5932-42 Germantown Avenue September 3rd CDR Comment Responses

5932-42 GERMANTOWN AVENUE

CIVIC DESIGN REVIEW

November 6th, 2024

DRIVEWAY
NOT ON CITY PLAN
12' WIDE

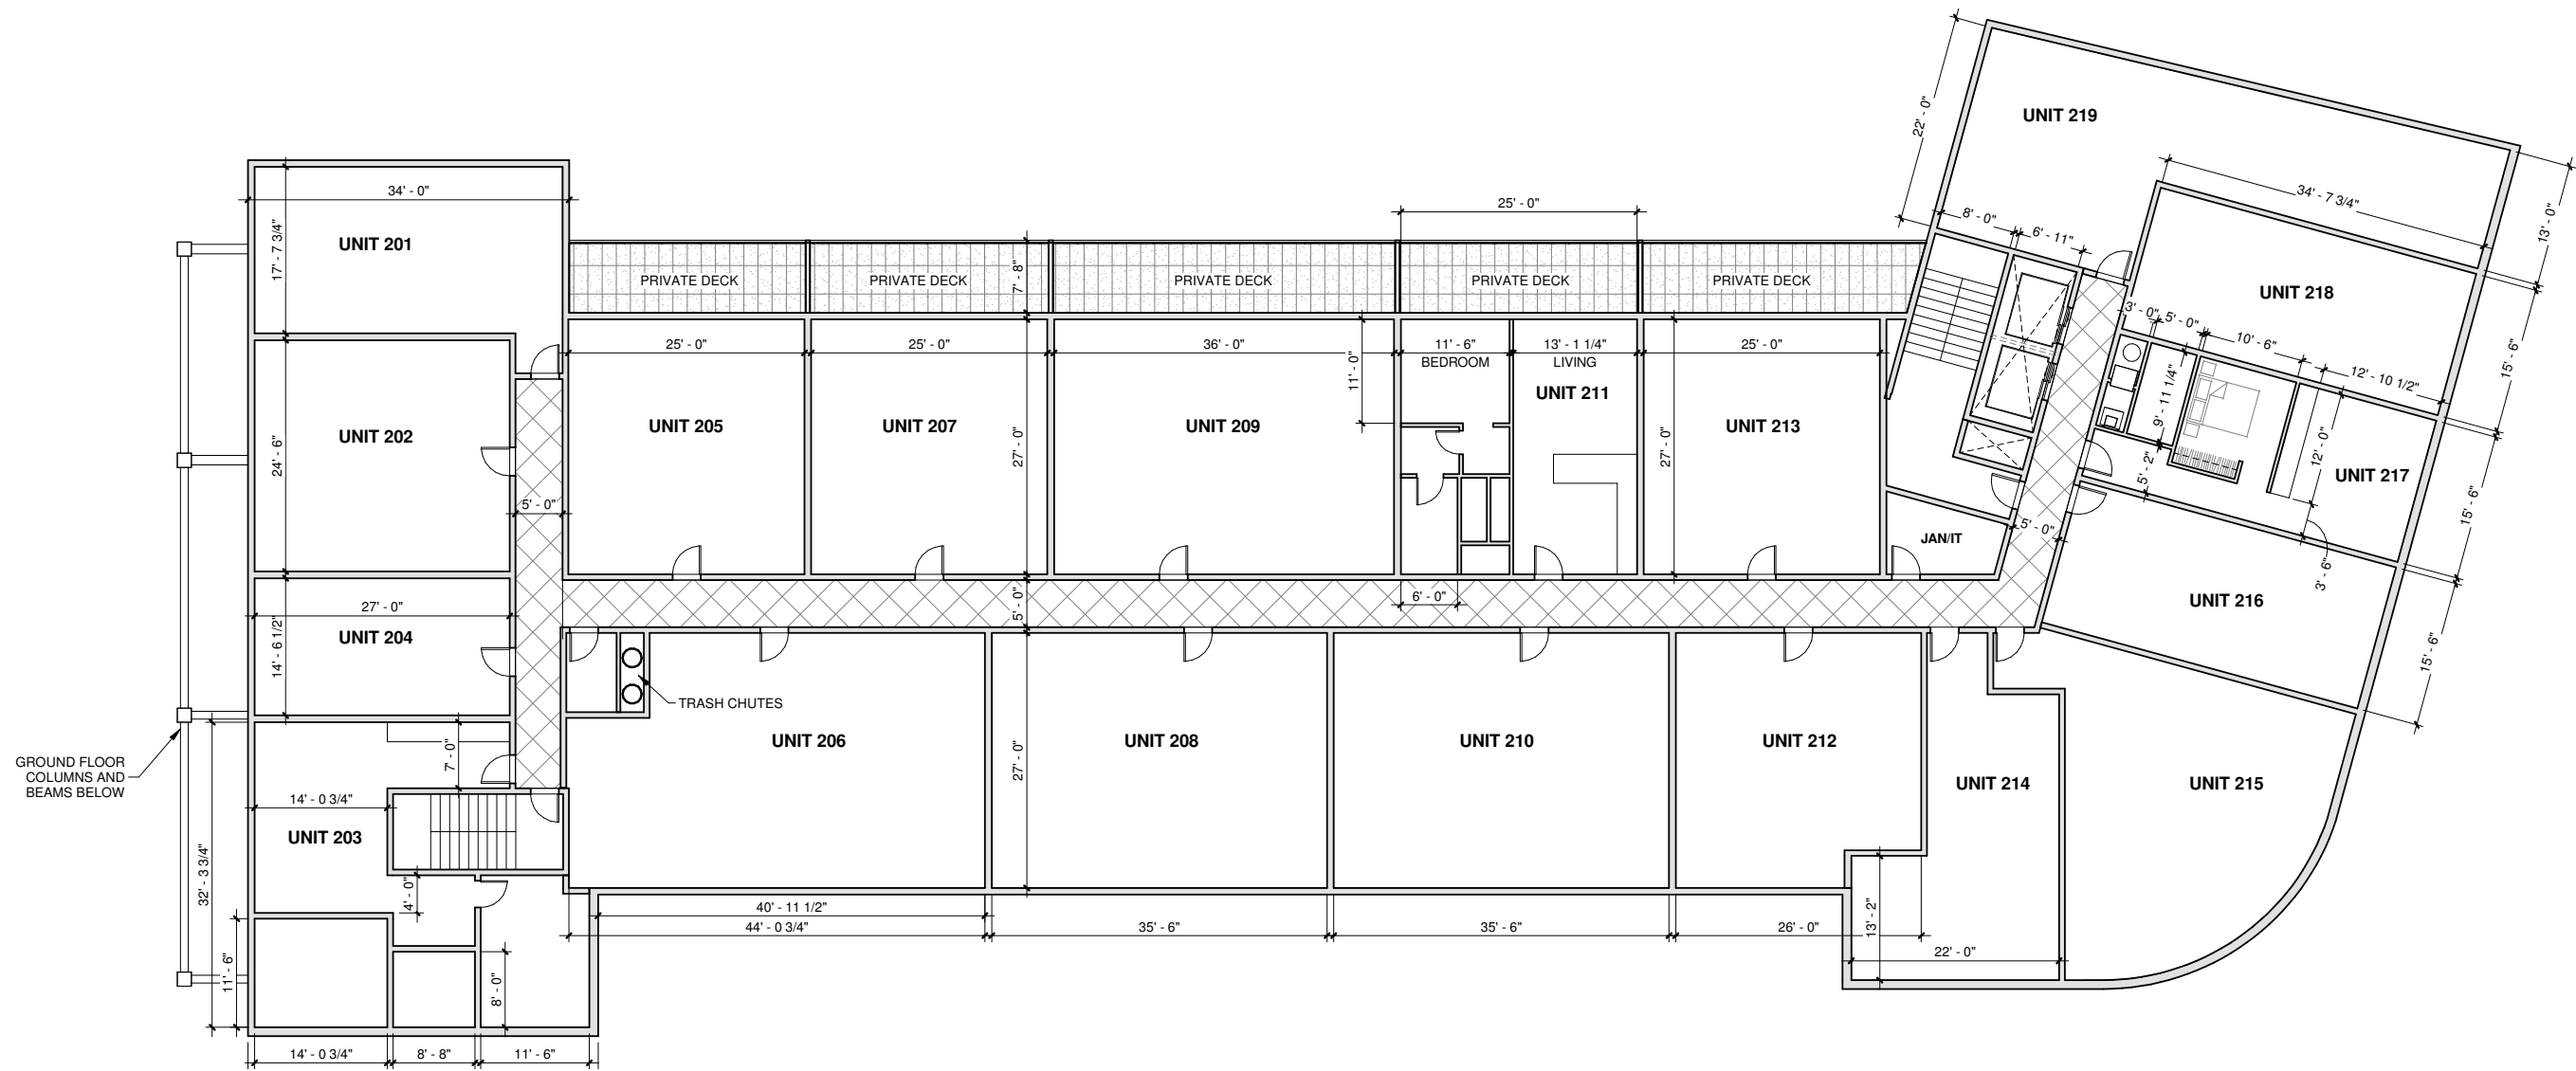
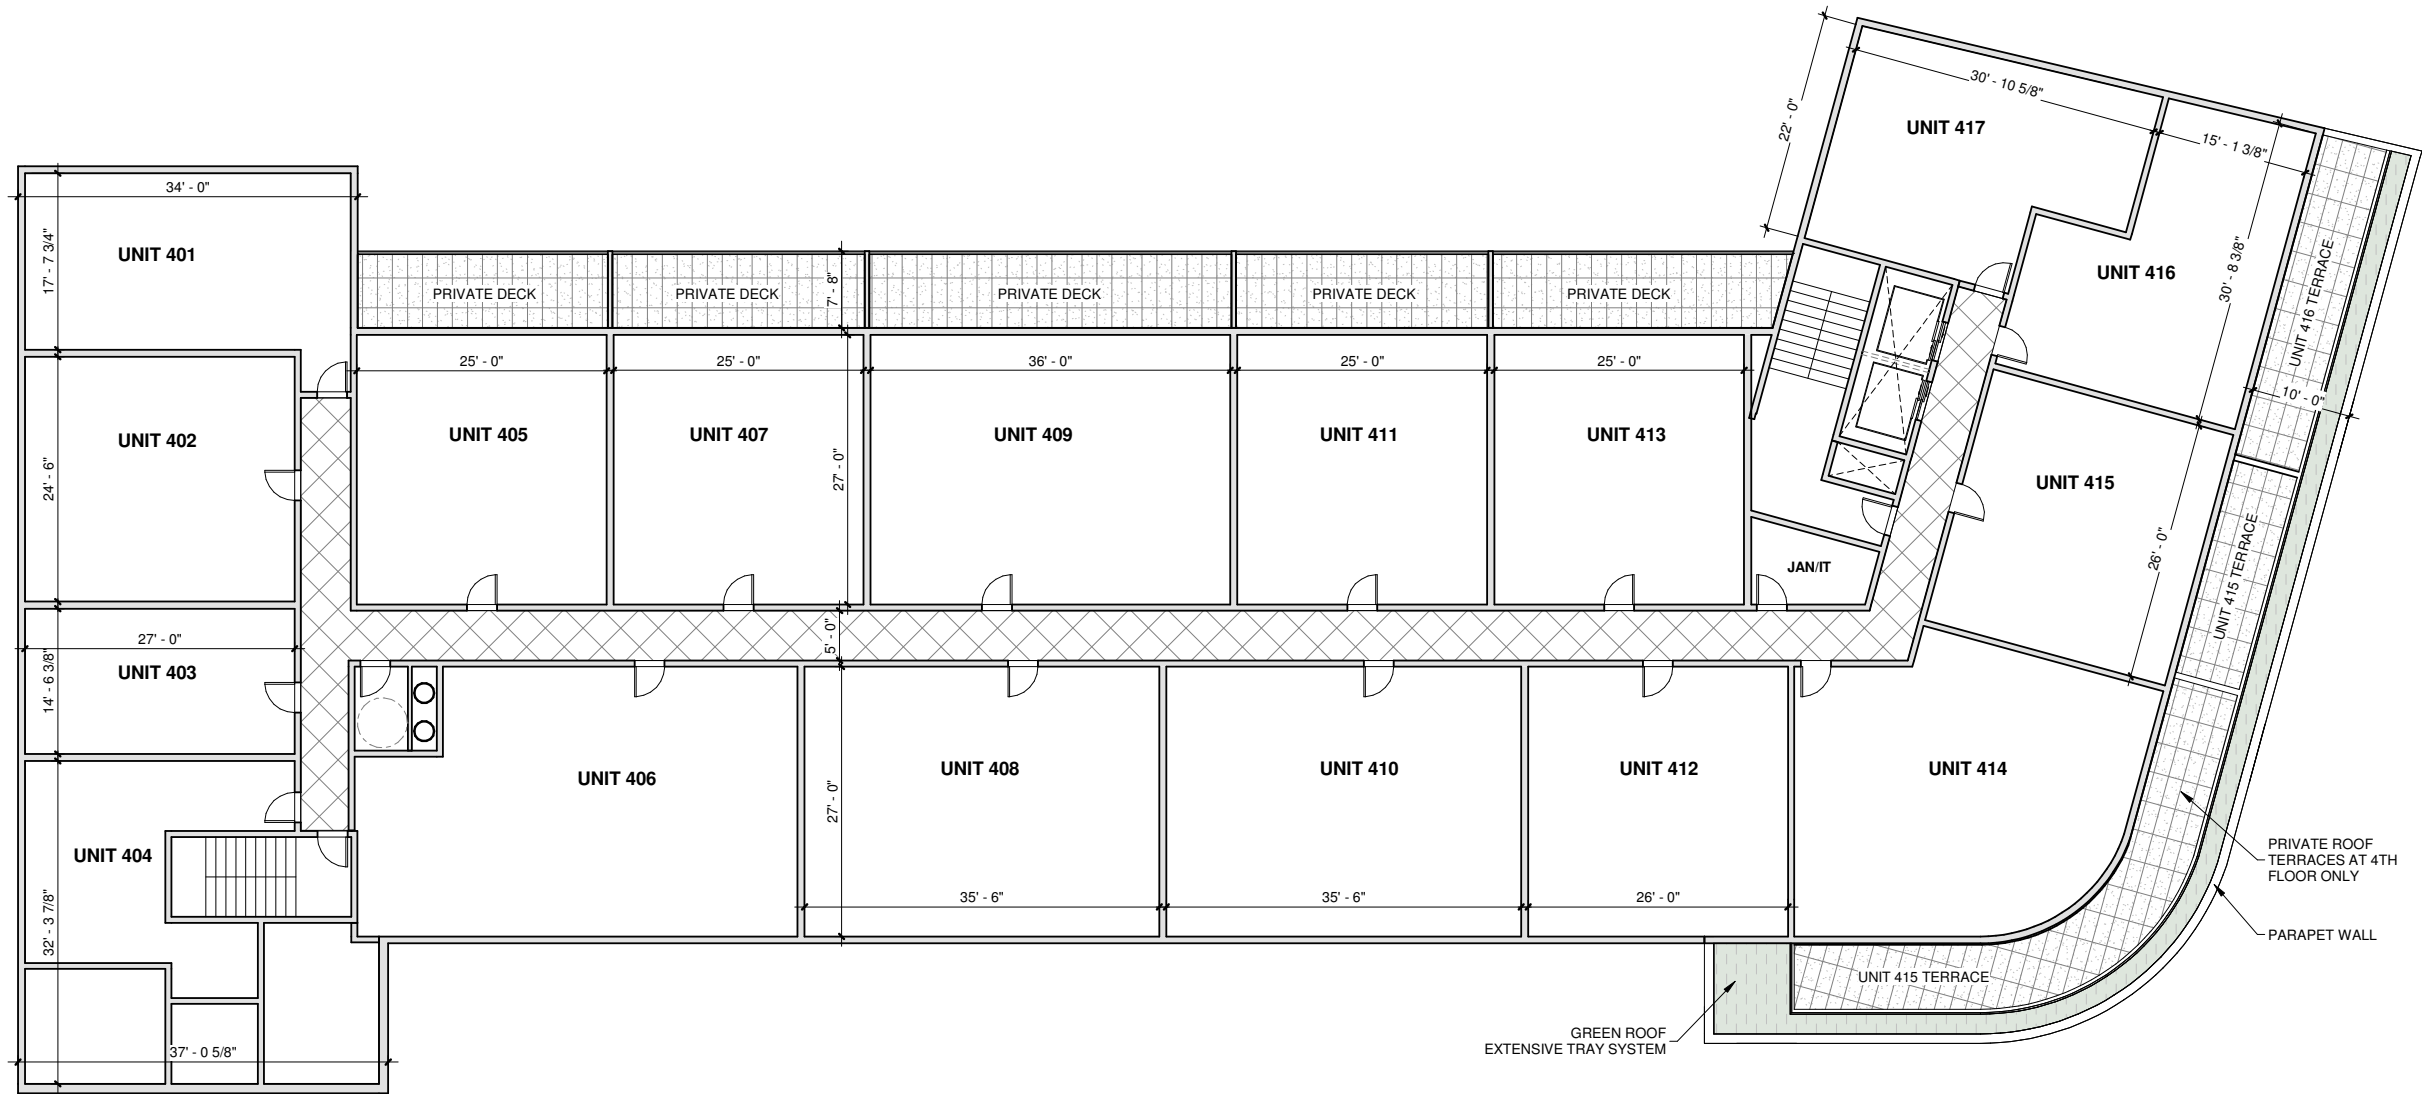
1. The driveway is 12 feet wide which makes it tight for two-way access. The Police Station uses this driveway for egress. The community would like to see a more formalized connection between the police department and developer.

5. Create a full sidewalk on the north side of the driveway. The driveway is currently in poor condition and there is room to create a full sidewalk. Consider creating a curbless driveway which would accommodate both vehicle and pedestrian traffic. All pedestrian access needs to be ADA accessible.

In the updated renderings, the Developer proposes moving the curb line inward by 5'3" along the northern side of the private driveway, thus widening a portion of the driveway to approximately 17' as suggested at the September 3 CDR meeting. See pages 7, 8, 18, and 22. Further, the Developer has not and does not expect to impede the Police Department's use of the private driveway. The Developer will continue private discussions with the Police Department to ensure their access to the driveway - as an unobstructed driveway benefits all parties. We also note that the Philadelphia Police Department has direct street access to Haines Street for both ingress and egress.

The Developer has revised the plans to move the curb line inward by 5'3" along the northern side of the private driveway. See pages 7, 8, 18, and 22. The Developer will

work with the Streets Department to ensure that all pedestrian access is ADA accessible.
